Case Number: **134916**

Property: 145 Old Pittwater Road, Brookvale
Your Reference: 46/23141
Plan Identification Number: 134916WW

Attached is the Waste Water Design Package for the location of works shown above. This package was received by Sydney Water and dated 15 July 2015/Version No. 12. **You have indicated that this plan is for tendering purposes.** After you have engaged a Constructor and the following matters have been addressed, this plan can be used for construction. If there are any changes after tendering, you must give us the appropriate Project Variation documents.

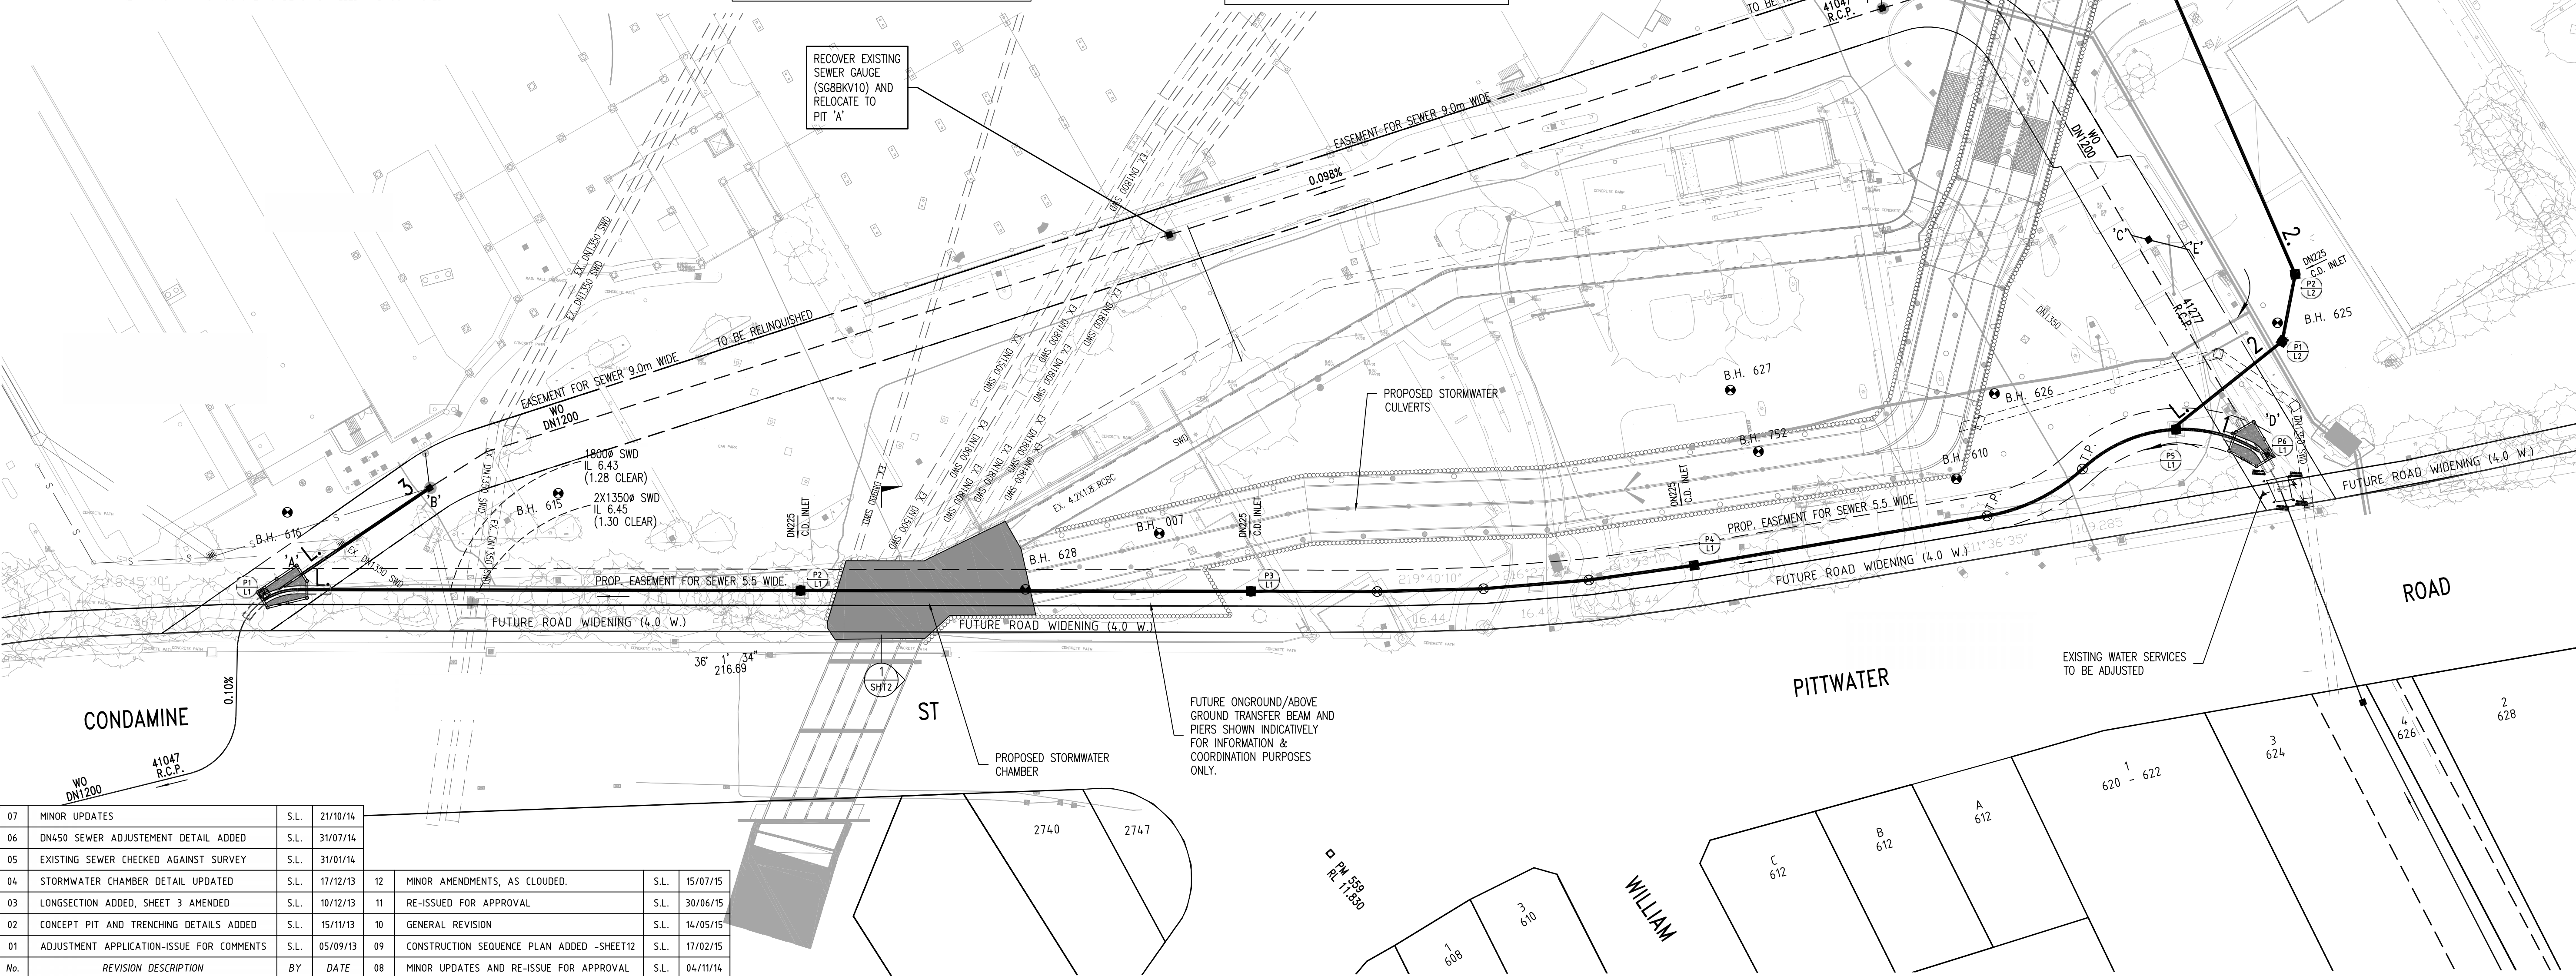
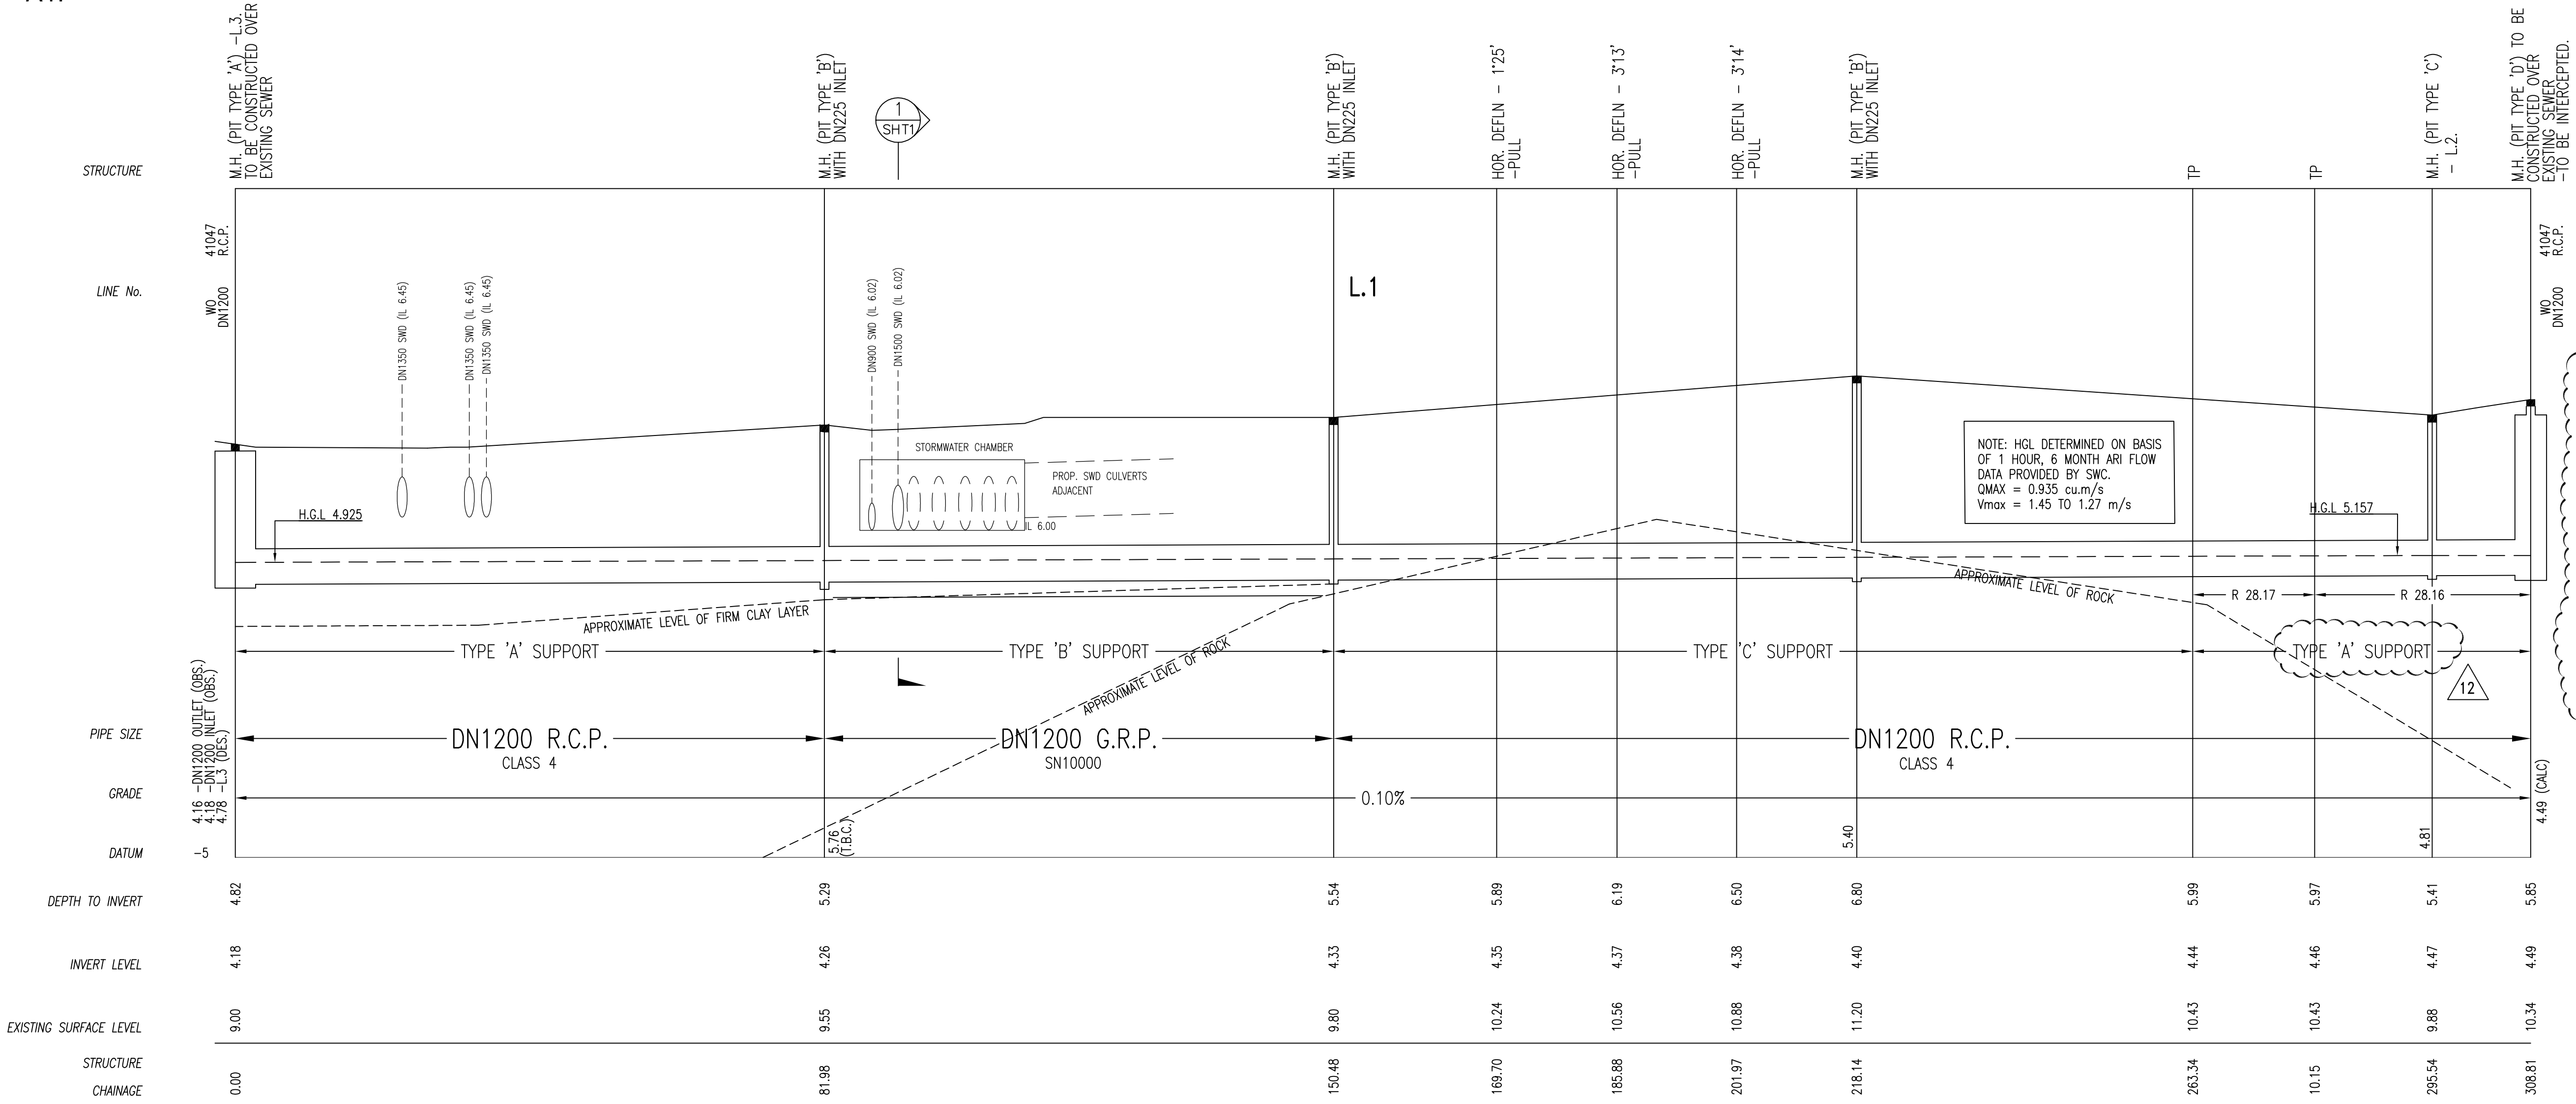
With respect to proposed Line 3, you will need to determine whether:

1. The DN1200 main is to be removed and the proposed DN300 is laid in its place. (easement extinguished/encumbrance removed). This is Sydney Water's preference.
2. Line 3 is removed from the design, the section of DN1200 is transferred (via deed of disuse and transfer) and connection is made to the chamber at 'A'.
3. The main is laid within the existing DN1200 main and the existing easement above that section will remain. (easement /encumbrance remains on the property)

SUGGESTED CONSTRUCTION SEQUENCING PLAN

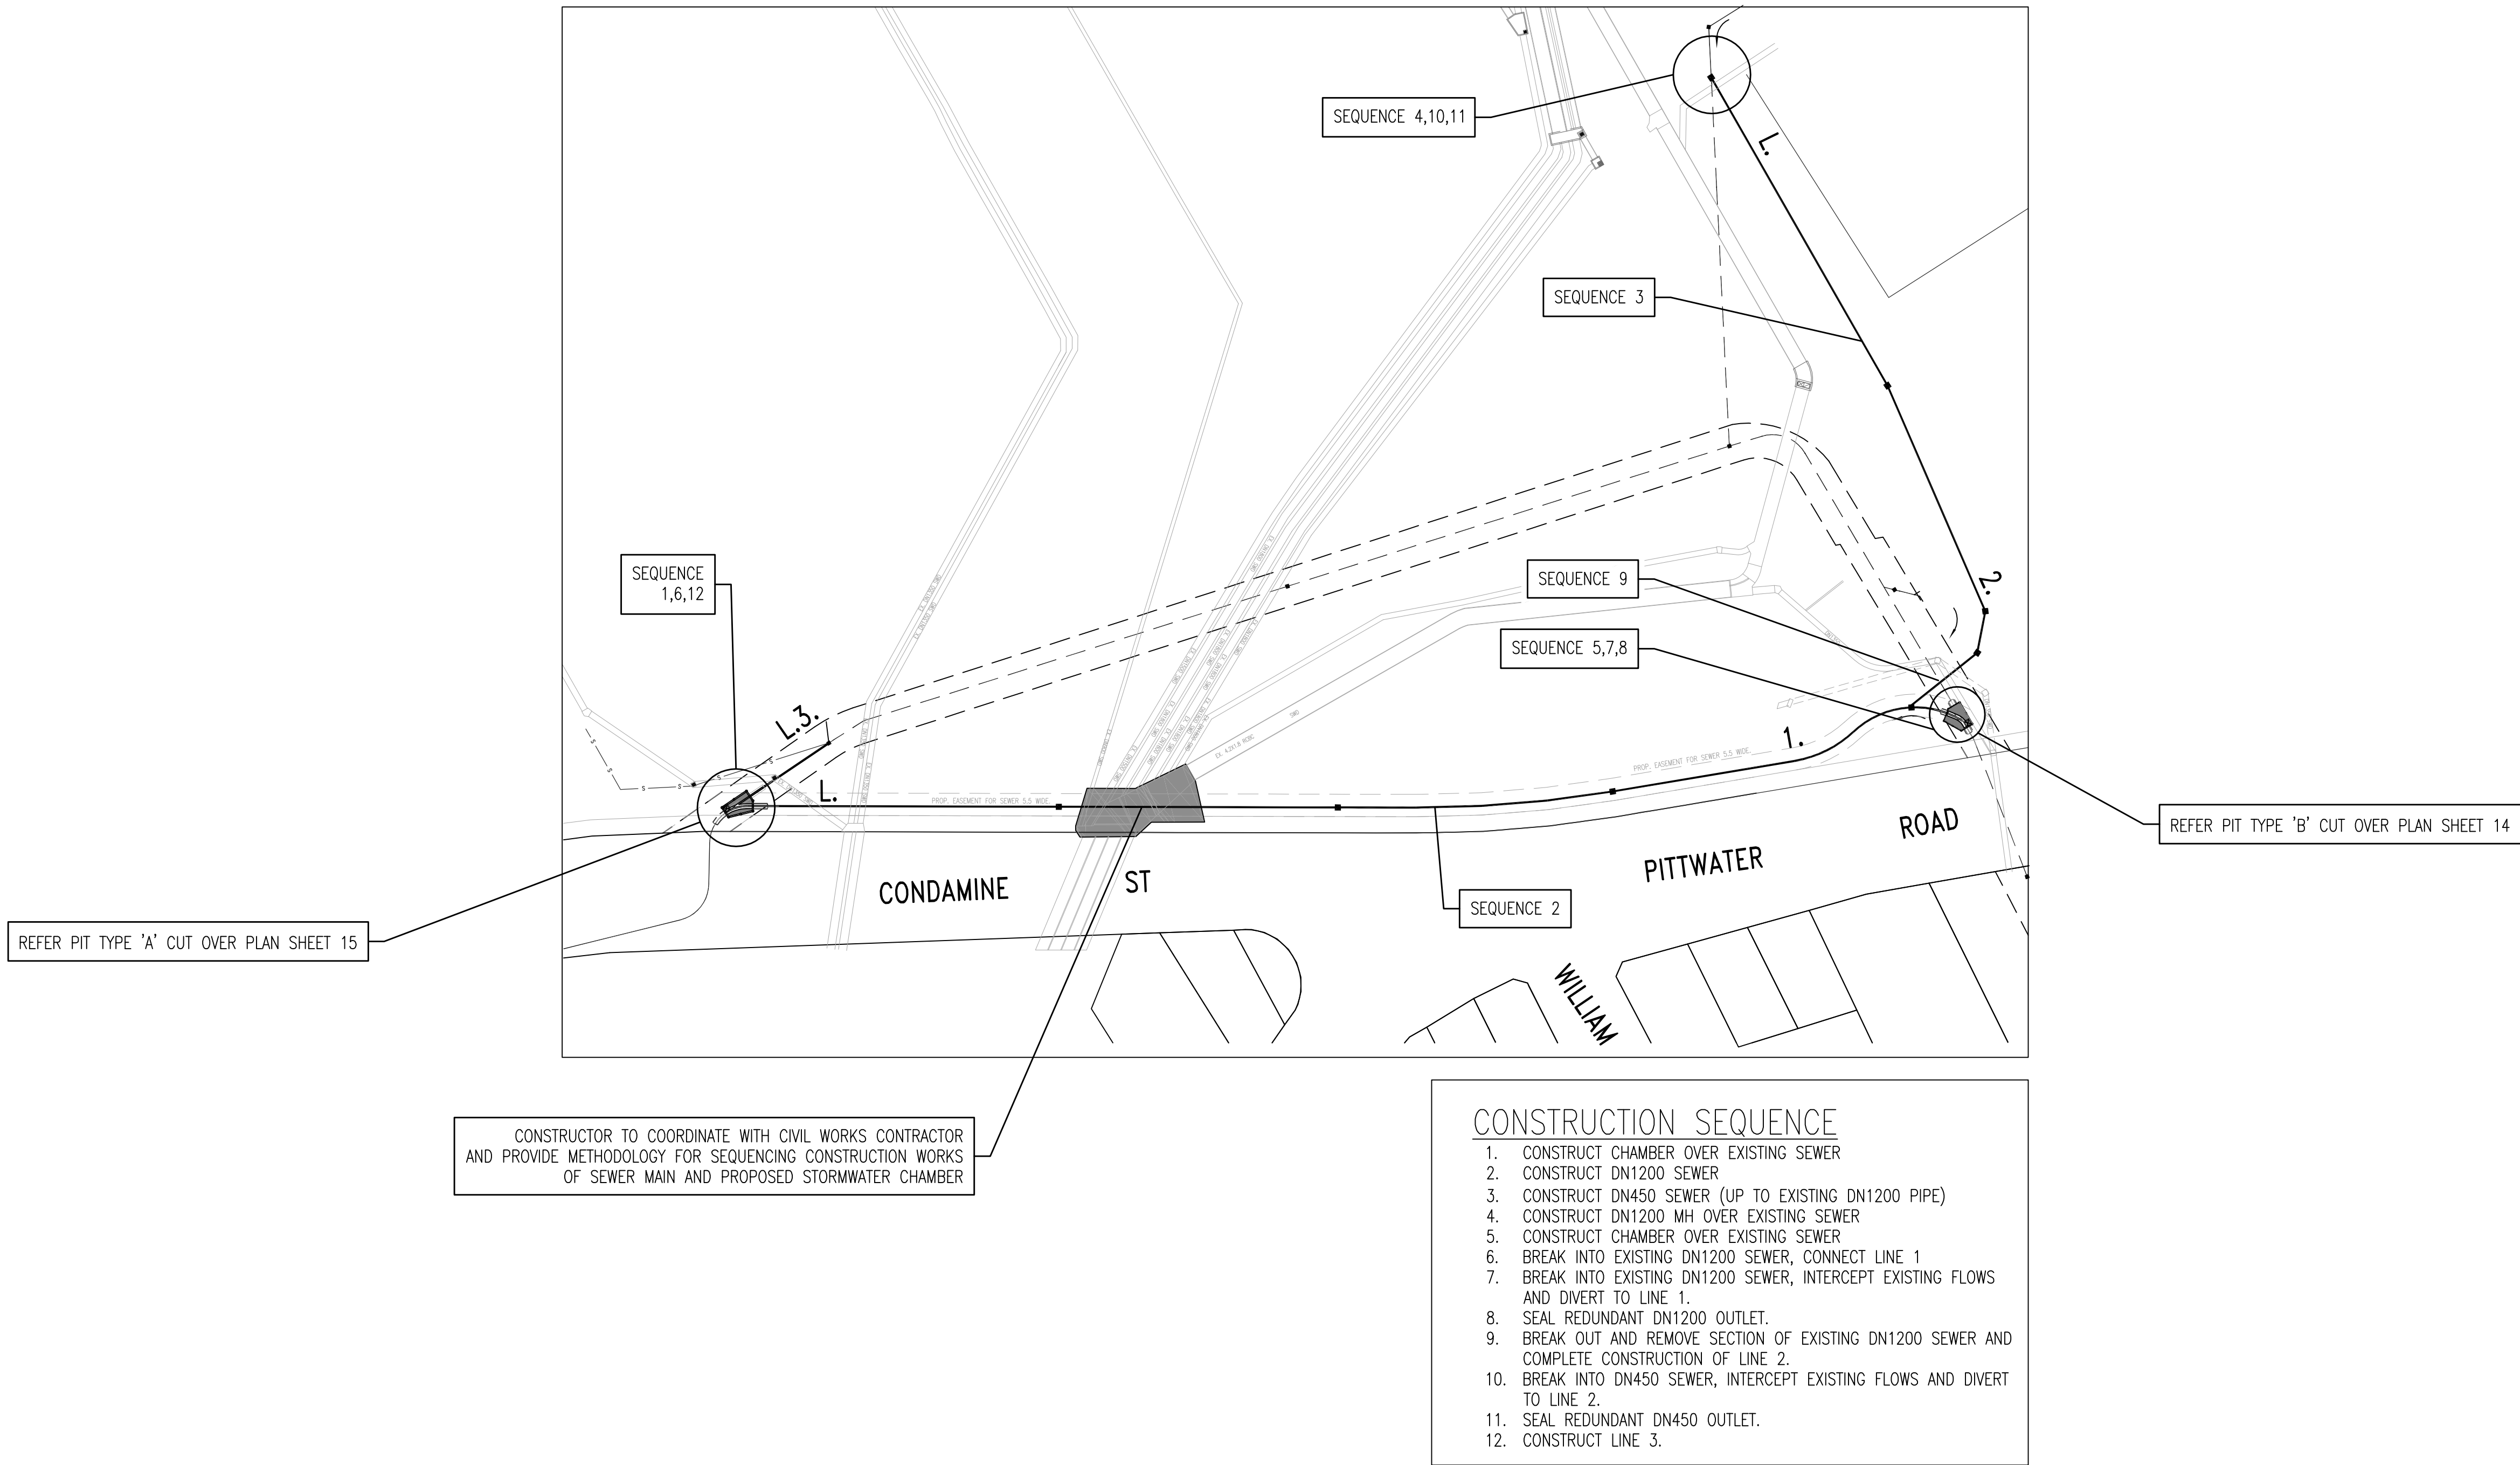
- At the last meeting, held Sydney Water asked about the duration of the steps. This

is important because at the MHs at either end of the new 1200, there are 750mm inserts during construction.

- If we are likely to have wet weather during the sequence construction step, then the 750mm sections will not cope and we are likely to have overflows in the system and possibly at the site. If the construction duration is long and wet weather cannot be avoided, then a contingency such as pumping needs to be considered.
